Access Compliance Report

Public Rights-of-Way

Intersection ID: 31891	Main Street: CENTERLINE_DR	Cross Street: MOUNTAIN_SPRINGS_DR	Location: NE
ADA ID: 7EC6E0C664F5	Ramp Type: BlendTrans1	Initial Pass/Fail: Fail	Overall Compliance: No
Codes/Mitigation Info/Possible Solution		Field Measurements/Component Compliance	
Severity Score: 8.75

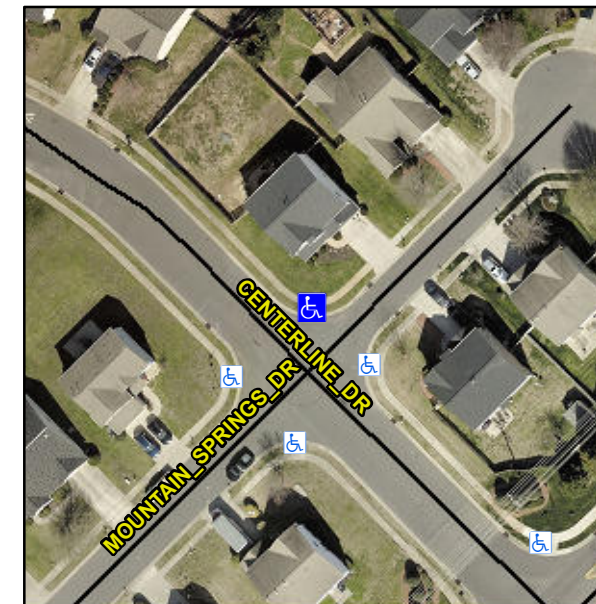
Not Found, R304.5.1

Compliance	Description	Data	Compliance	Description	Data
N/A	Ramp Length (in)	47.5	Yes	BlendTrans Slope (%)	3.9
No	Ramp Width (in)	38.5	Yes	BlendTrans XSlope (%)	0.9
N/A	Flare Type LT	N/A	N/A	Flare Type RT	N/A
N/A	Flare Slope LT (%)	N/A	N/A	Flare Slope RT (%)	N/A
N/A	Flare Traversable LT?	N/A	N/A	Flare Traversable RT?	N/A
N/A	Landing Length (in)	N/A	N/A	DWS Provided?	N/A
N/A	Landing Width (in)	N/A	N/A	DWS Contrast?	N/A
N/A	Landing Slope (%)	N/A	N/A	DWS Length (in)	N/A
N/A	Landing X Slope (%)	N/A	N/A	DWS Full Width?	N/A
N/A	Landing Curb? (Y/N)	N/A	N/A	DWS Offset (in)	N/A
N/A	Shared Landing?	N/A			
N/A	Gutter Ponding?	N/A	N/A	Gutter Slope (%)	N/A
N/A	Gutter Lip Ht (in)	N/A	N/A	Gutter X Slope (%)	N/A
N/A	Painted X Walk1?	No	N/A	Painted X Walk2?	No
	X Walk 1 Direction	To SW		X Walk 2 Direction	To SE
	X Walk 1 Width (in)	N/A		X Walk 2 Width (in)	N/A
	X Walk 1 Slope (%)	1.3		X Walk 2 Slope (%)	0.6
	X Walk 1 X Slope (%)	1.7		X Walk 2 X Slope (%)	1.5

N/A	Ramp inside XWalk1?	N/A	N/A	Ramp inside XWalk2?	N/A
	Road Slope (%)	1.1		Clear Space?	N/A
	Road X Slope (%)	0.3	N/A	Clear Space to XWalk (in)	N/A
N/A	Any Obstructions?	N/A	N/A	Storm Grate/Utility Hazard?	N/A
	Obstruction Type			Storm Grate/Utility Type	
		N/A			N/A
			Yes	Surface Condition? (G/P)	Good
			No	Curb Slope (%)	9.9

Remove & Replace Curb Ramp With Two New Directional Ramps or Equivalent.
